AMENDMENTS TO THE DRAWINGS:

REMARKS

Title: LASER DIODE AND METHOD OF MANUFACTURING
THE SAME USING SELF-ALIGN PROCESS

Appln. No.: 10/813,157

FIG. 4A

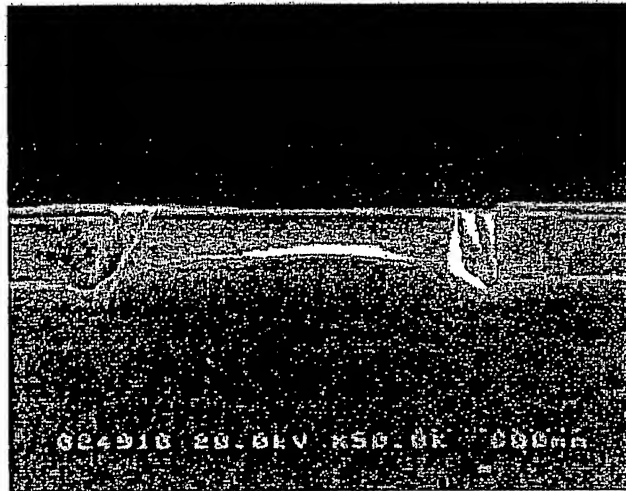
The attached drawing sheet includes changes to Fig. 4A. This sheet replaces the original sheet that includes Fig. 4A. In Replacement Sheet 1, Fig. 4a was amended to include a "Prior Art" legend.

On page 2 of the Office Action, the Patent Office suggested that Figure 4a be designated by a "Prior Art" legend. Applicants appreciate this suggestion and have amended Figure 4a accordingly.

Prior Art
